# Technical Service Bulletin

**Cobra Motorcycle Mfg.**

## TSB0411 50cc Output Shaft

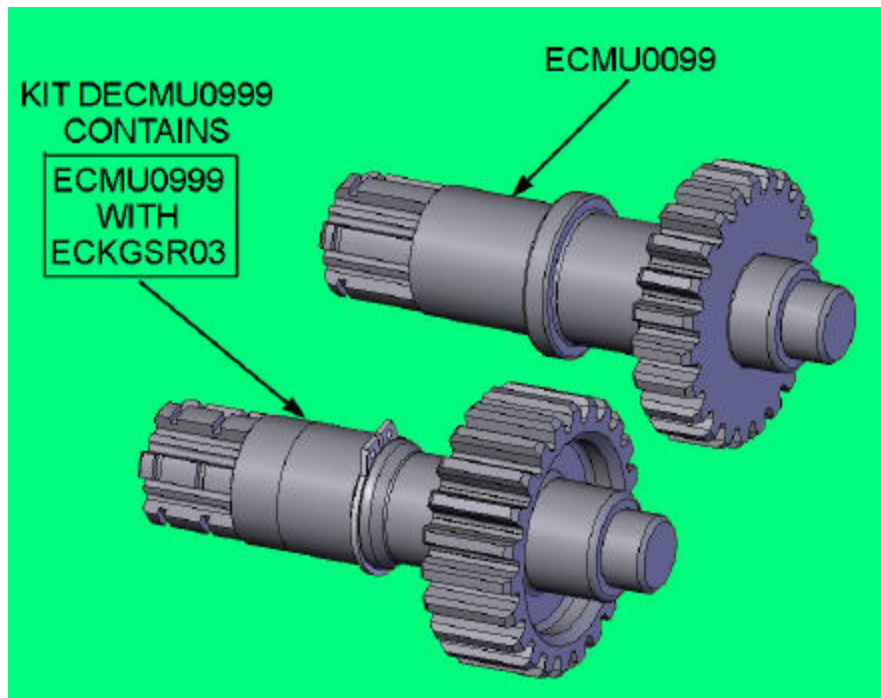
From 2006 through 2010 the output shaft on the King and JR/CM models has been ECMU0099. From this time forward, the service replacement part for these models will be the output gear ECMU0999 with a snap ring ECKGSR03 sold together as a Descriptor Kit DECMU0999.

This new gear and clip is the 2011 production hardware.
